### To Our Valued Customers,

This PCN affects our iMX6 SoloX COM board (product number: EAC00244 and EAC00256).

Below is a picture of the new rev PC1 board.

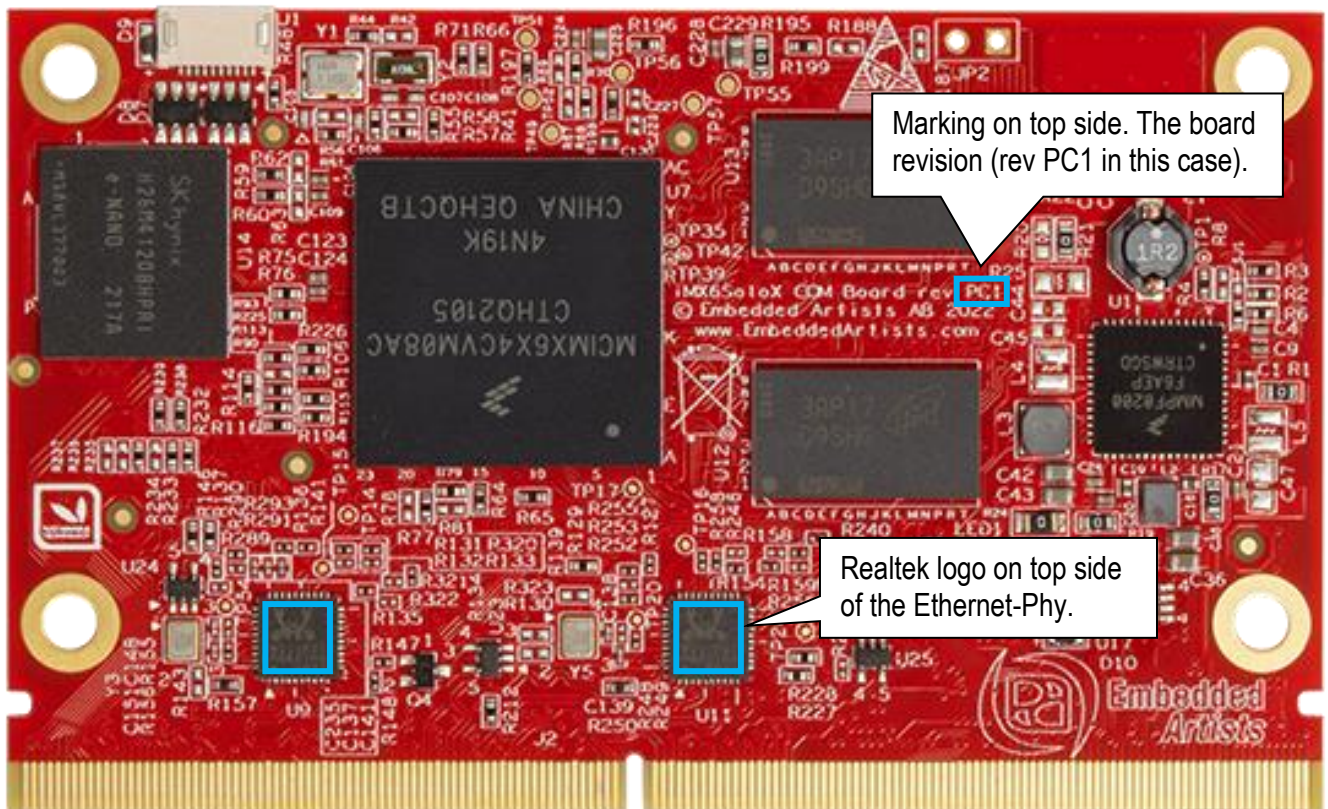
The Gigabit Ethernet Phy, AR8031 from Atheros, is not available on the market. We have replaced it with RTL8211FDI from Realtek. Although the update only has minimal software implications it is not 100% backward compatible.

The new replacement product is named EAC00433 (and matches the original EAC00256, i.e., industrial temperature range). EAC00433 is also a replacement for EAC00244.

The new Ethernet-Phys will be mounted on boards produced after January 2023. All boards from Embedded Artists have a marking: WO-XXXX-YYWW, where XXXX is the WO-number. YY is the year and WW is the week number when the board was produced.

The affected boards will have a WO-number above or including:  $XXXX \geq 1179$  and revision PC1 or later.
